MN1586 – Design Note

Topic: Building Z1 Villa, Removal of existing Chimney to Northern Elevation

Location of damaged chimney:

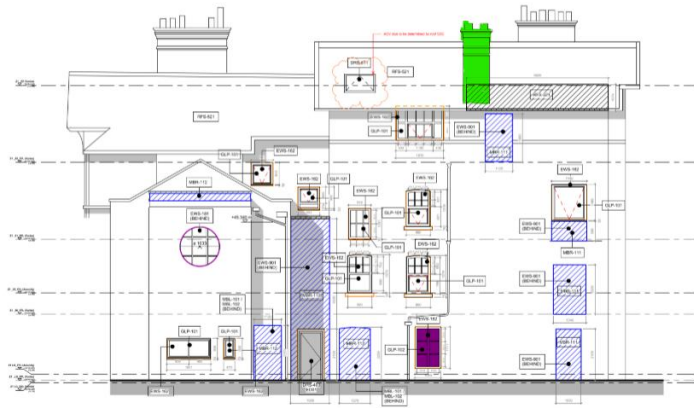
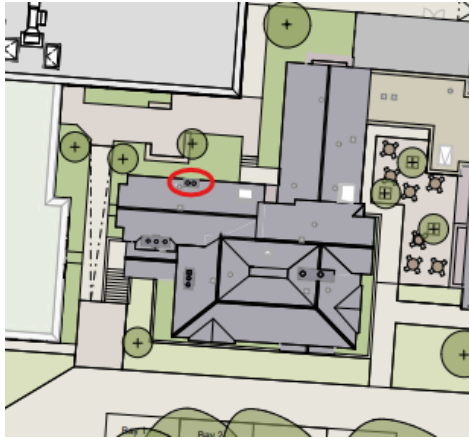
Upon investigation of the chimney, we identified that the whole stack was unstable and beyond repair and the existing bricks have deteriorated due to age and weathering.

Images showing stack out of plumb and quality of brickwork:

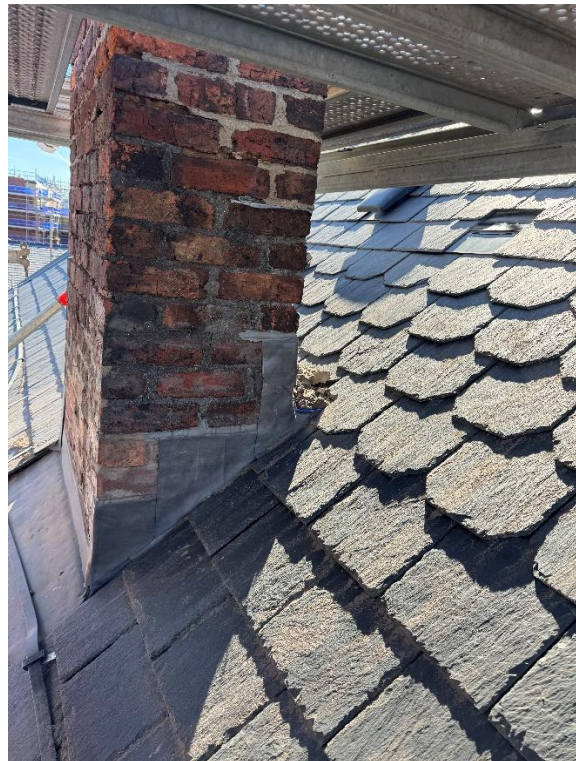
Due to the extent of the damage, and in concerns of health and safety we have dismantled the chimney.

We have sort advice from the Structural Engineer, who advised that under current Building Regulations Part A, it states that a chimney cannot extend more than 4.5 times the minimum plan dimension.

The existing chimney was constructed from imperial bricks and measured approximately; 466mm deep x 942mm wide x 2975mm high.

Under the current regulations and using new metric bricks, the maximum the chimney could be constructed is approximately 440mm deep x 890mm and based on the 4.5 times rule at a maximum height of 1980mm.

But due to further internal works and adjustments, we concluded that there is insufficient suitable structure to bear the chimney on, so propose to completely remove and replace with roof covering.
